TITLE - COLLAPSABLE CCA ROOF

DWG NO - NTPL-401-PM-04

PRODUCT - RETRACTABLE ROOF
CLIENT NAME - NEOTRAFO SOLUTIONS
SITE LOCATION - HYDRABAD
MATRIAL - QTY - 1
If any queries contact - info@nihva.com
PROJECTION METHOD:
SCALE :
ALL DIMENSION ARE IN mm A2
SHEET 1 OF 2

CLOSE VIEW

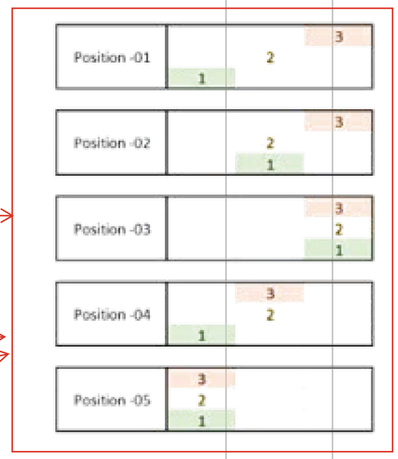
Lights fixing provision is also to be done for all the doors

No horizontal support will be there in the door lapping area

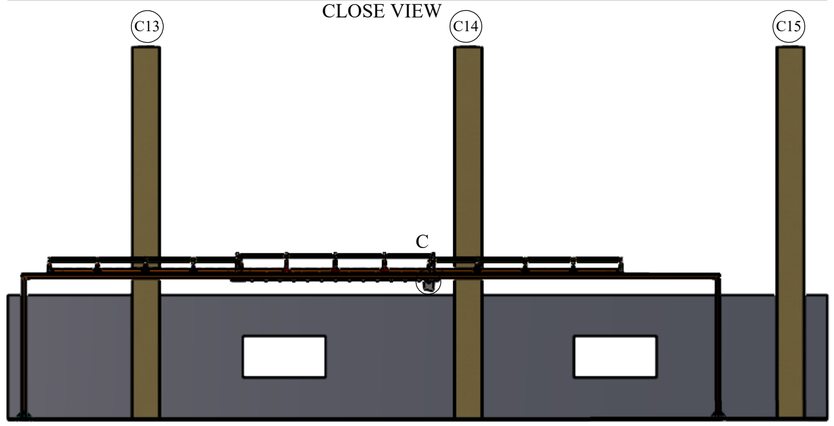
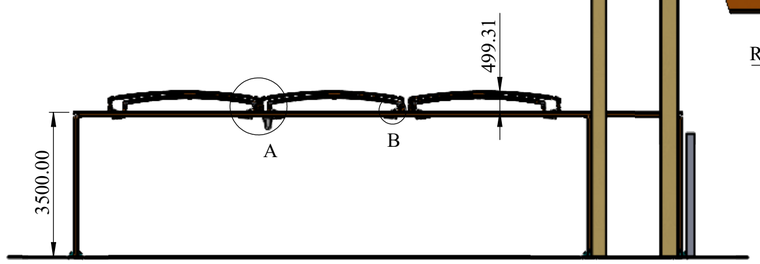
Check this Area in this area 3 layers off room will be there for our operation but it was shown only 2 nos

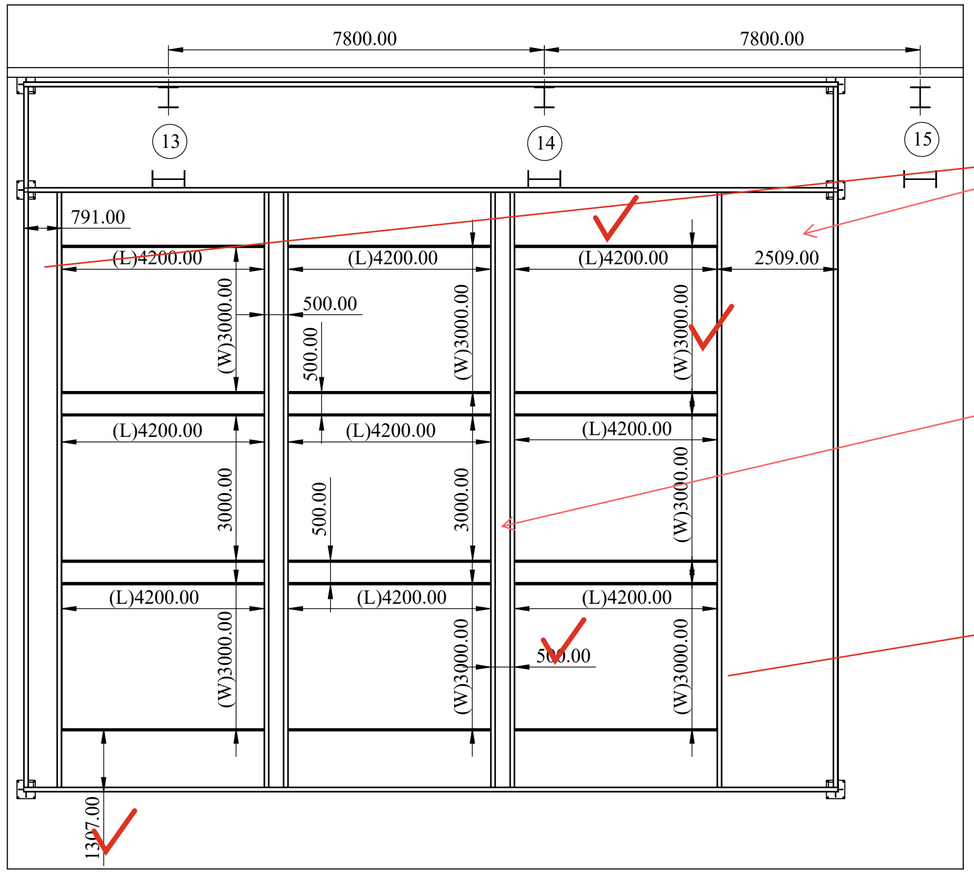
(2509+791)/2

position this doors in Room center

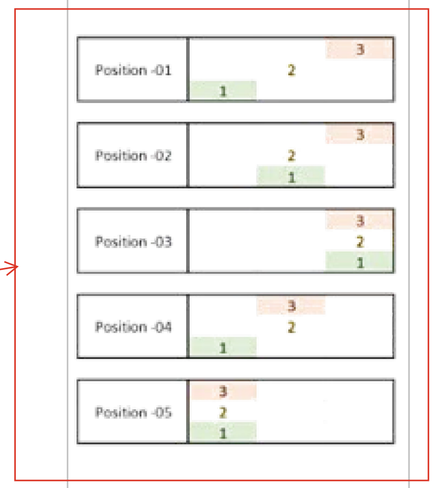
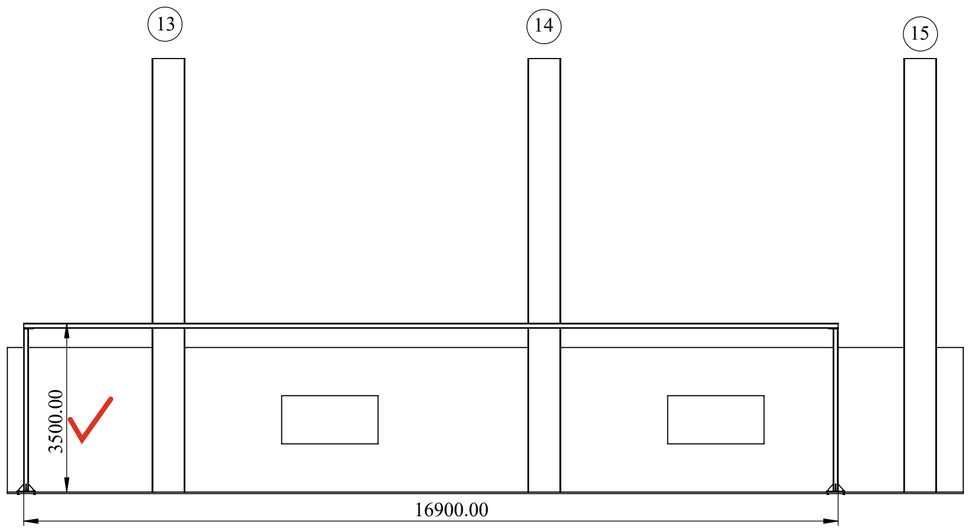
No horizontal support will be there in the door lapping area
